**Licence Number** L7798/1993/6

**Licensee** Deflector Mining Limited

**Premises** Gullewa Gold-Copper Operations  
Mining Tenements M59/49, L59/49, L59/64, M59/68,  
M59/356, M59/391, M59/392, M59/335, M59/442  
L59/35, M59/507, M59/336, M59/522 and L59/71  
Morawa - Yalgoo Road

**Date of Amendment** 20 July 2018

**Figure 2: Sentinel 2 satellite image - 24 October 2017**

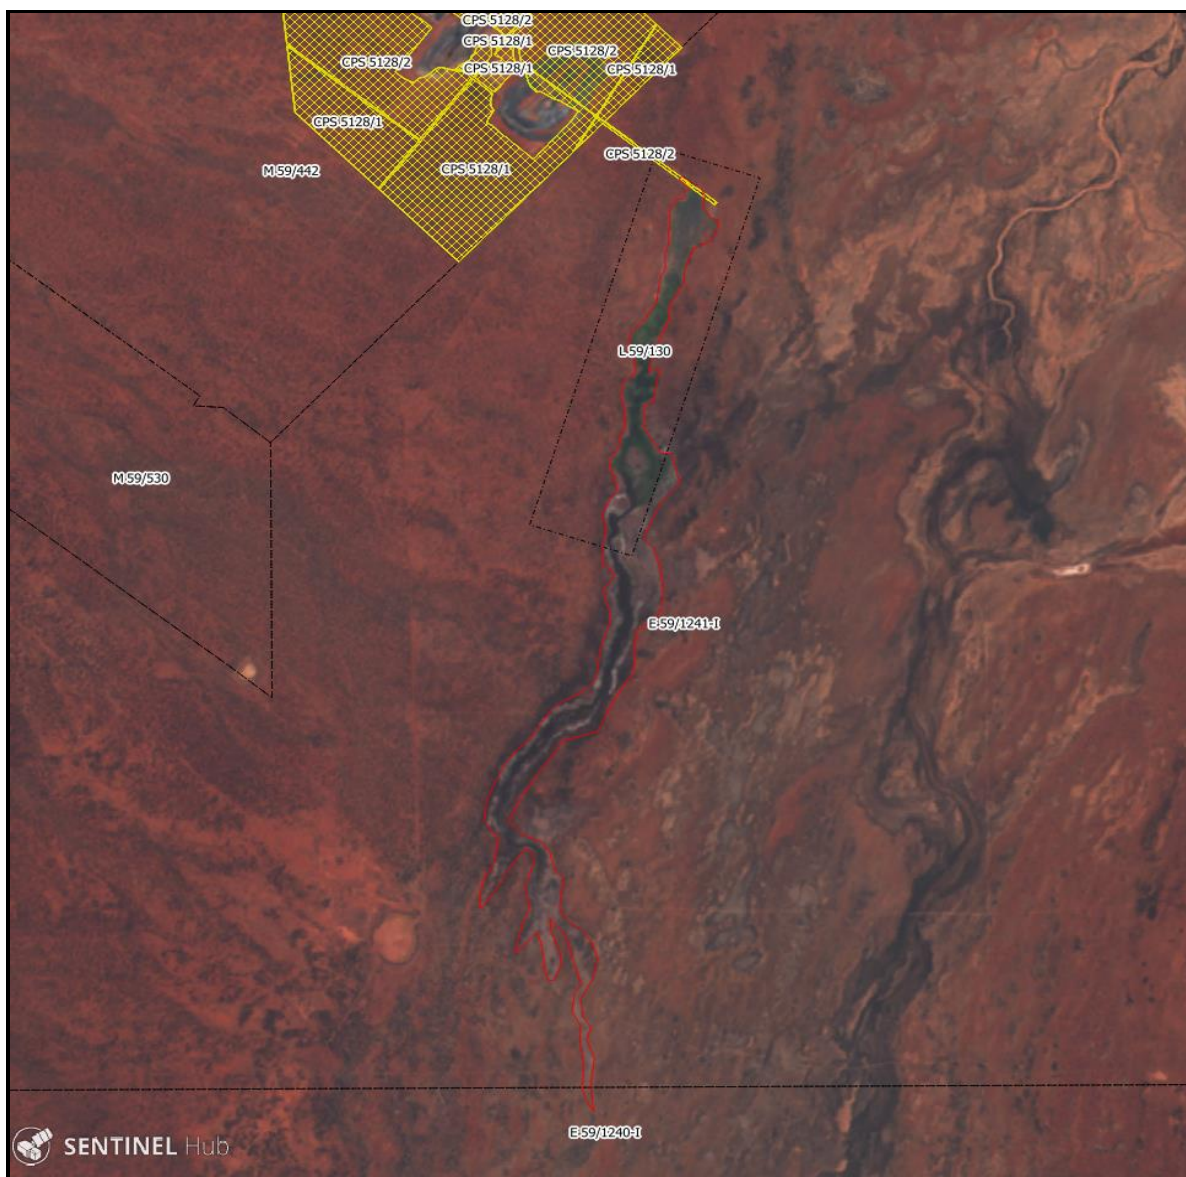
Satellite imagery review undertaken by DWER identified that approximately 75 ha of vegetation has been affected downstream of the discharge point (Figure 2).

A desk top survey by DWER using satellite imagery (Figure 2) shows that since the recommencement of mining in September 2015, and the discharge of dewatering water to the Salt River discharge location, there has been a significant impact on vegetation with up to 75ha being affected.

Approximately 75 hectares of change outlined in red. Northern portion appears to be inundated with change extending up to 5 kilometres south.

Figure 3: Monthly extent of the dewatering discharge

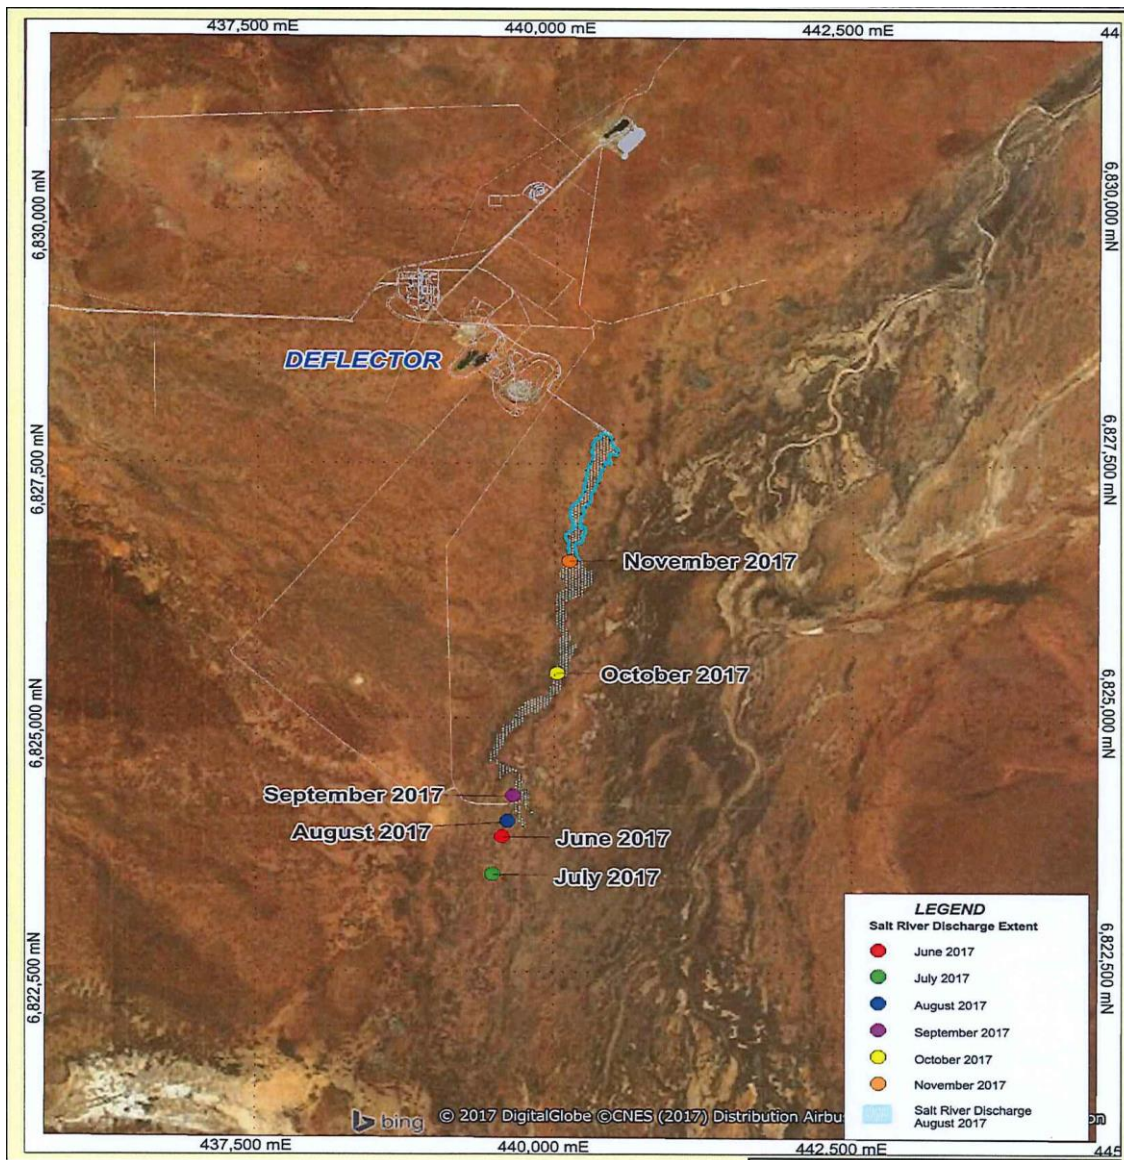
The Licensee has conducted monthly field monitoring since June 2017 to determine the extent of the dewatering discharge. Figure 2 below indicates the extent when dewatering discharge rates were above 60 L/s in July 2017. Since then, this area has reduced in size as a result of reduced rates of discharge, which is now down to around 13.5 L/s (6 March 2018) due to an increased reuse of dewatering water within the processing plant, for dust suppression and the use of evaporators at the TSF. This is expected to rise during the winter months when evaporation rates are lower, however is not expected to return to the highs of July 2017 (around 60 L/s) due to improved water management measures at the Premises. As a result, the continued dewatering discharge at an increased rate above the Licence limit, however well below historical levels, is expected to remain within the already impacted area from previous dewatering discharges.

**Figure 4: Soil sampling locations**

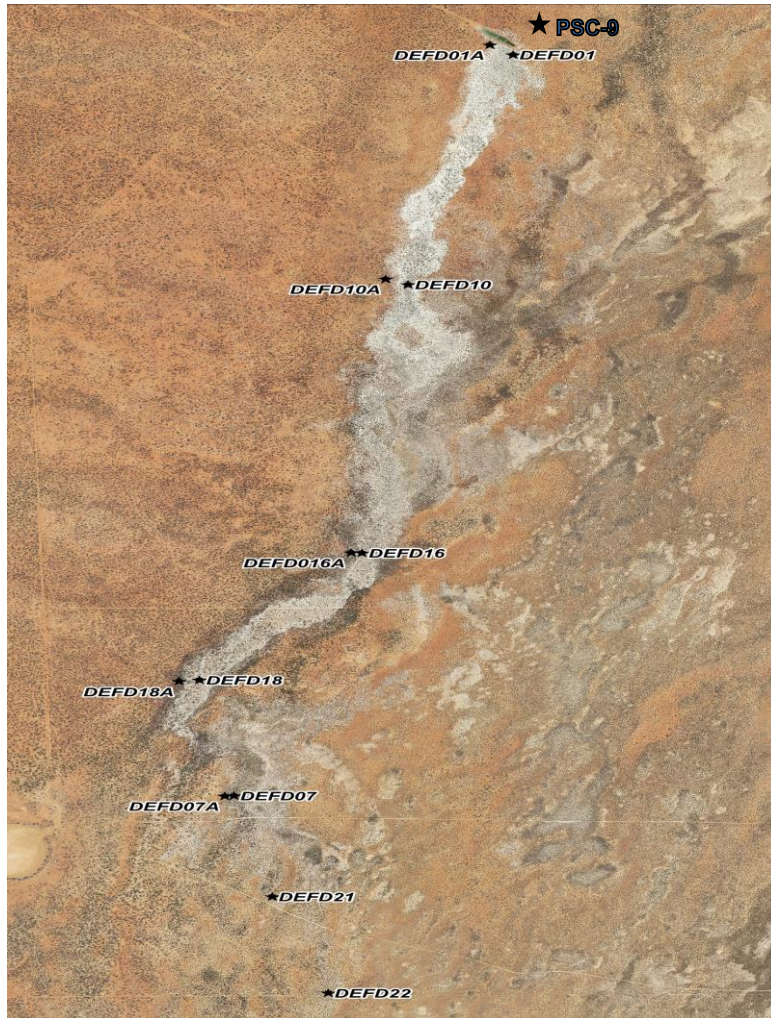
The Licensee has also undertaken soil sampling within the impacted area to determine the concentrations of particular metals. A control site upstream of the discharge area was also sampled for comparison. The results from the soil sampling are presented in Table 9 below. The sampling locations are presented within Figure 4.

Sampling results show that the concentration of metals within soils reduces with distance from the Salt River discharge location. Sampling at the dewatering discharge terminus (DEFD01) shows the concentrations of metals were above the control site sample with copper noted to be six times and nickel over twelve times the levels sampled at the control site; these concentrations are shown to reduce with distance to levels just over the control site.

Recent soil sampling (19 December 2017) conducted within the impacted dewatering discharge area, indicates that the concentration of metals within soils reduces with distance from the Salt River discharge location (see Table 9 and Figure 4). Sampling at the dewatering discharge location (DEFD01) shows the concentrations of metals were above the control site sample with copper noted to be six times and nickel over twelve times the levels sampled at the control site; however these concentrations are shown to reduce with distance to levels just over the control site. With the Salt River located 1.5 km away from the dewatering discharge area, the concentrations of any metals that maybe flushed into the Salt River as a result of a heavy rainfall event are expected to reduce even further. Additionally, there are large volumes of water associated with heavy rainfall events which would dilute the concentration of metals even further.
